Town of Simsbury

RE: BID: WPCA/DPW 2021-01
WOODLAND STREET SEWER REPLACEMENT PROJECT Simsbury,
Connecticut

This **Addendum No. 1** includes answers to questions, clarifications, revisions, and additions to the Invitation for Bid. Modifications are hereby made to the Invitation for Bid issued June 14, 2021, for the above-referenced project.

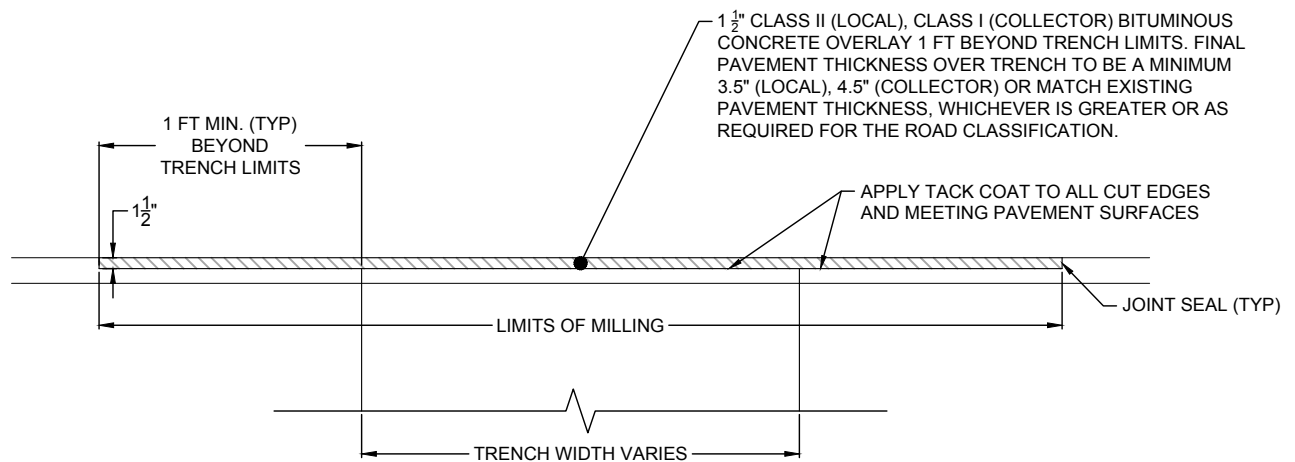
18. The spec calls for 2" sand & 6" topsoil for lawn restoration? Please clarify.

Answer: For lawn restoration, the depth of loam is to be a rolled 6-inch thickness. DELETE reference to the 2" minimum sand layer shown on the "Typical Loam and Seed Detail" shown on the Drawings. UPDATE Paragraph 3.2.A of Section 02920 (Lawns and Grasses) to reflect a 6-inch depth of loam.

Pavement Repair Detail

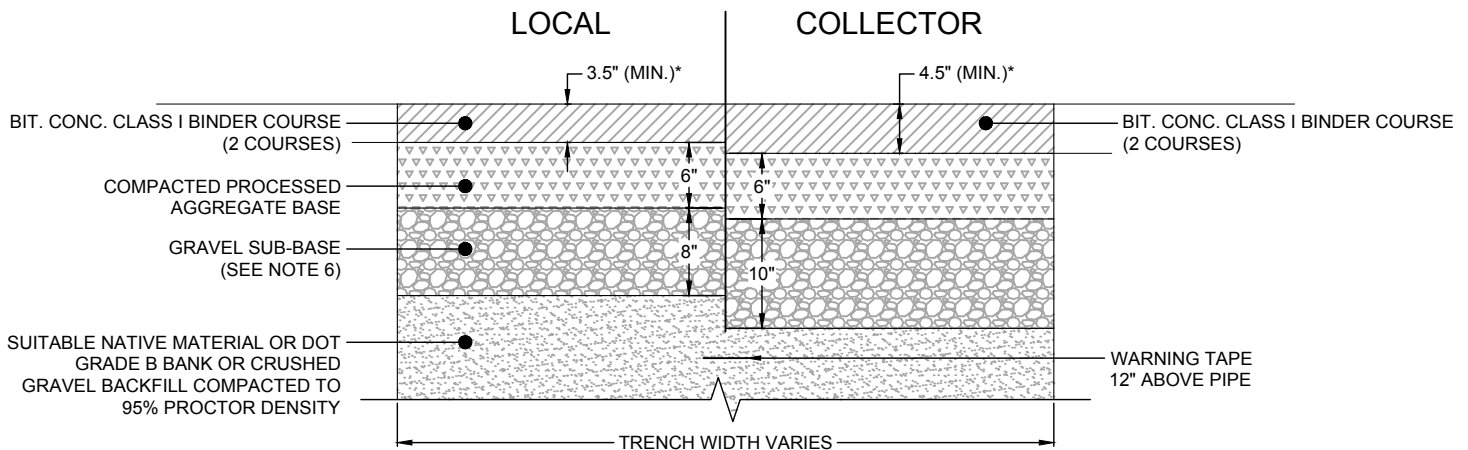
- 7. Is bid item #24 (Full-Width Milling and Overlay) intended to be an 1-1/2 mill & overlay on Woodland Street from approximate STA 0+00 to 5+00? Please verify location and provide a detail clarifying depth of mill and thickness of pavement.**

15. Will the Town require Temporary Bit Pavement in Woodland Street?

16. What are the depths of Milling & Bit Overlay? Town & State?

Answer: For work within the Town ROW at Woodland Street / Woodland Place the depth of milling and overlay is 1½". Pavement thickness over the trench shall be a minimum of 3½" (local road) or match existing pavement thickness, whichever is greater. Follow the permanent trench detail and any additional standards provided with the Street Excavation Permit. An updated Town of Simsbury *Pavement Repair Detail* is attached.

Answer: Yes. A temporary trench restoration is required for any disturbance of the existing pavement within the Town Right-of-Way (ROW) at Woodland Street / Woodland Place and a permanent trench is then required typically 6-9 months after the temporary trench is laid, both as shown in the Town of Simsbury *Pavement Repair Detail* (attached). A Street Excavation Permit is required for any work within a Town ROW and the contractor shall follow all additional conditions and details provided with the permit.

Answer: For work within the Town ROW at Woodland Street / Woodland Place the depth of milling and overlay is 1½". Pavement thickness over the trench shall be a minimum of 3½" (local road) or match existing pavement thickness, whichever is greater. Follow the permanent trench detail and any additional standards provided with the Street Excavation Permit.

**Typical Driveway
Apron Detail**

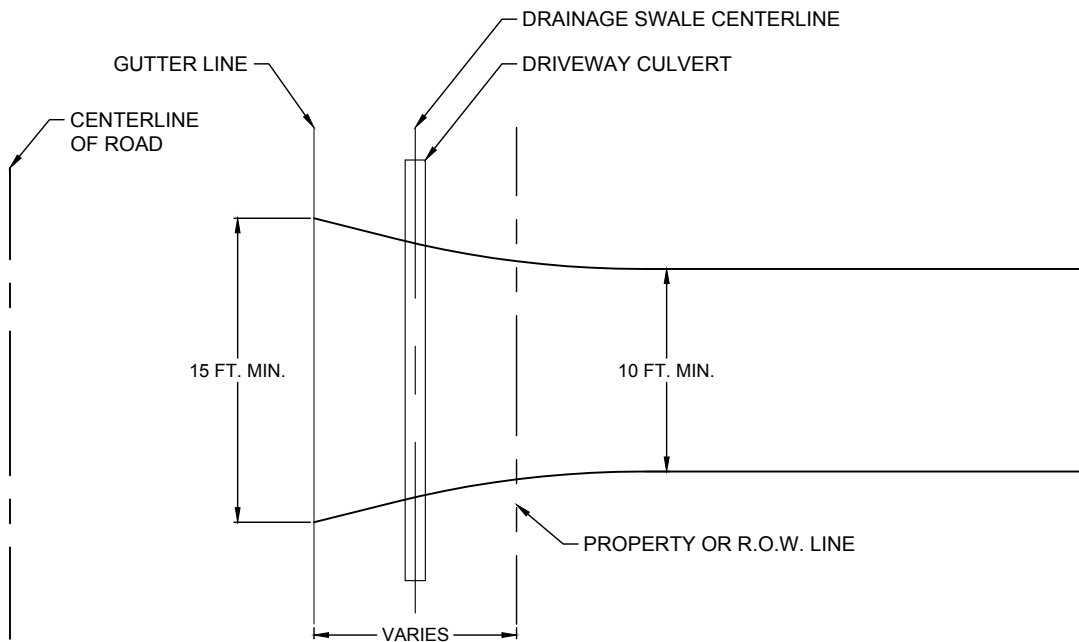
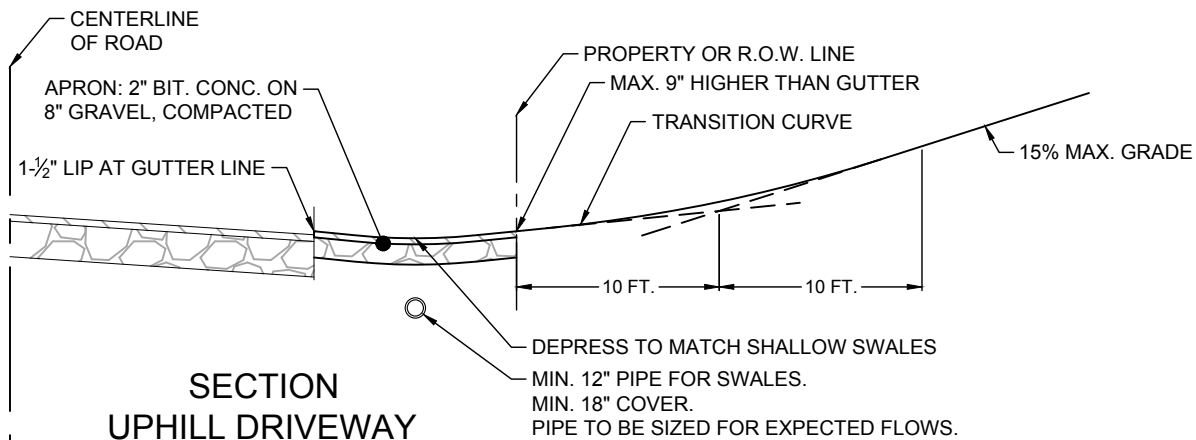
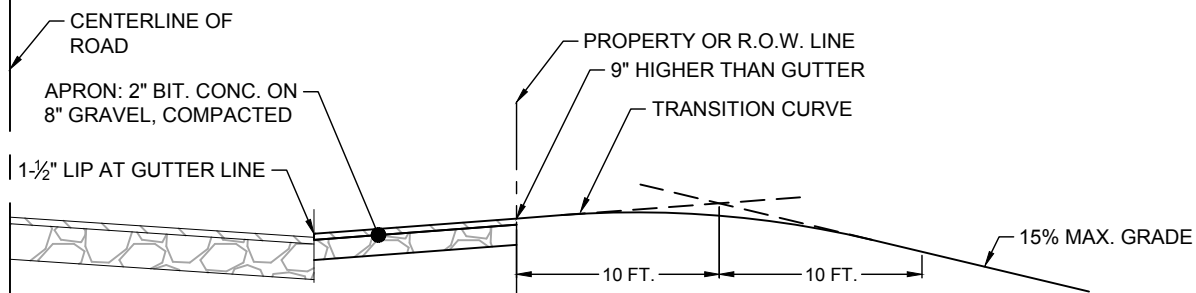
14. Will driveways need Temp Bit Pavement?

Answer: Temporary bituminous concrete at driveway aprons will be required. Permanent aprons should be constructed as part of the permanent roadway restorations in accordance with the Town of Simsbury *Typical Driveway Apron Detail* (attached).
